**From:** WJ Shack <wjshack@anl.gov>  
**To:** Joe Muscara <JXM8@nrc.gov>  
**Date:** Fri, Jun 16, 2000 8:47 AM  
**Subject:** IP-2 NDE Problem

### Subject/Message: IP-2 NDE Vugrafs (5/3/2000)

# SG 24, R2C5 - 1997 Midrange +Point Data

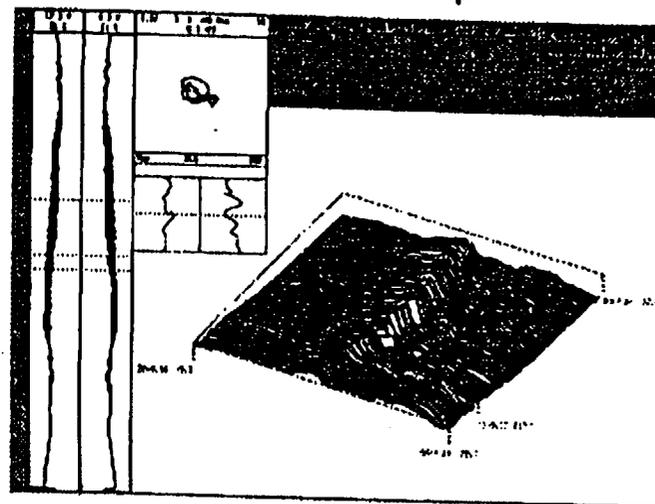
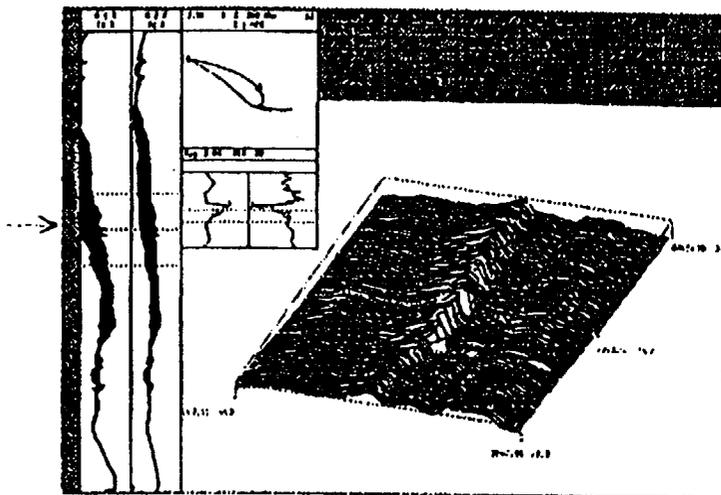
Viewgraphs 6 and 7 of the May 3, 2000 presentation by ConEd compare 1997 vs. 2000 setups applied to 1997 +Point U-Bend data (for R2C67 and R2C5). It appears that the purpose of this comparison is to show that the 2000 set up leads to R2C5 crack detection but not the 1997 setup and that both setups applied to R2C67 data reveal the crack clearly. Sasan and Dave have pointed out an apparent weakness in the ConEd explanation for why the R2C5 crack was missed. If you go to their viewgraph comparing the 1997 and 2000 setups (Slide 7 attached), they are suggesting that the difference in setup makes a big difference in the resulting Lissajous figure, and hence in the decision as to whether or not there is a crack. However, in slide 7 (R2C5) they are not examining the Lissajous figure at the same axial location whereas they are in slide 6 (R2C67). Note that the 2000 signal is analyzed at the location of the two (very small) signal blips, whereas the 1997 signal is analyzed at a different location. Sasan says that when he analyzes the data using the 1997 and 2000 setups, there is very little difference in the Lissajous figures when he takes them at the same location. Give Dave or Sasan a call to discuss further.
